**ADDENDUM NO. 1  
TO SPECIFICATIONS AND PLANS FOR THE  
CLAWSON PARK IMPROVEMENTS  
CITY OF ROYAL OAK  
OAKLAND COUNTY, MICHIGAN**

Date: December 13, 2024,

HRC Job No. 20240545

ADDENDUM #1

**INFIELD MATERIAL DETAIL**  
NOT TO SCALE

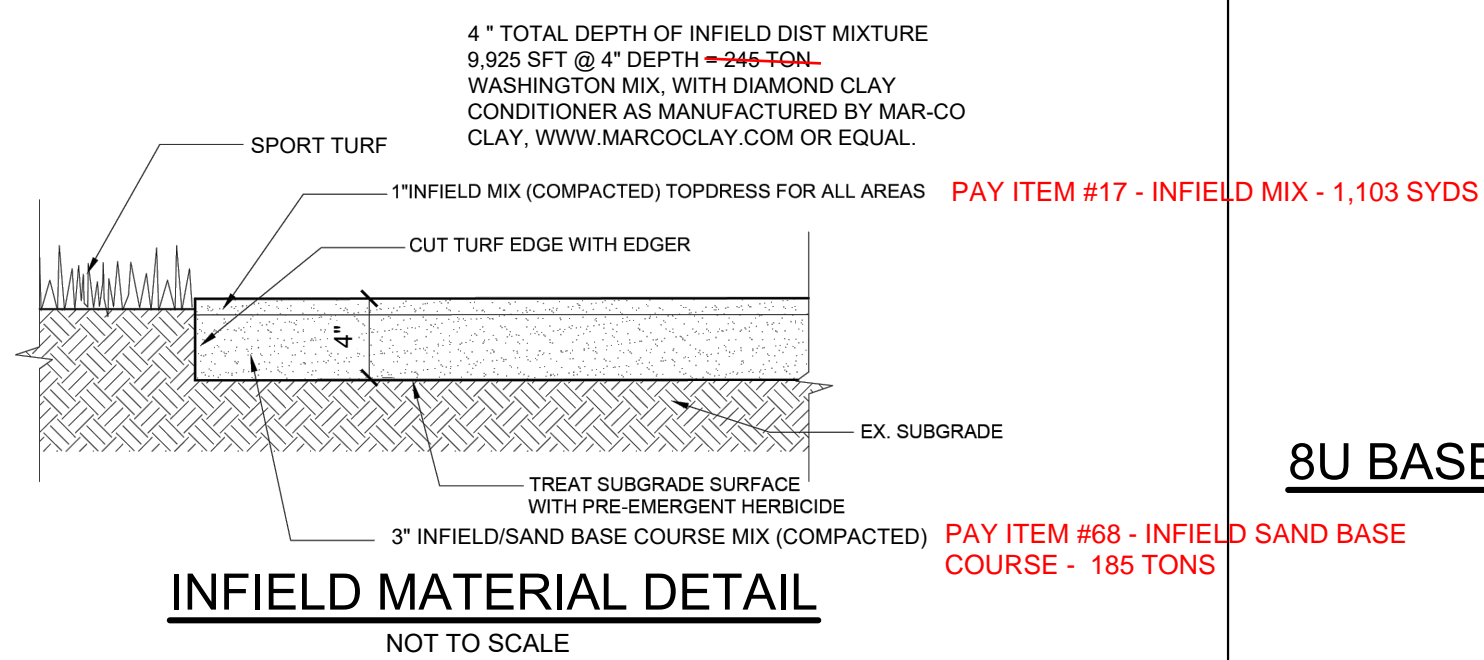
- SHEET 04 – REISSUE
  - Reissued with modified 'Infield Material Detail' and pay items.
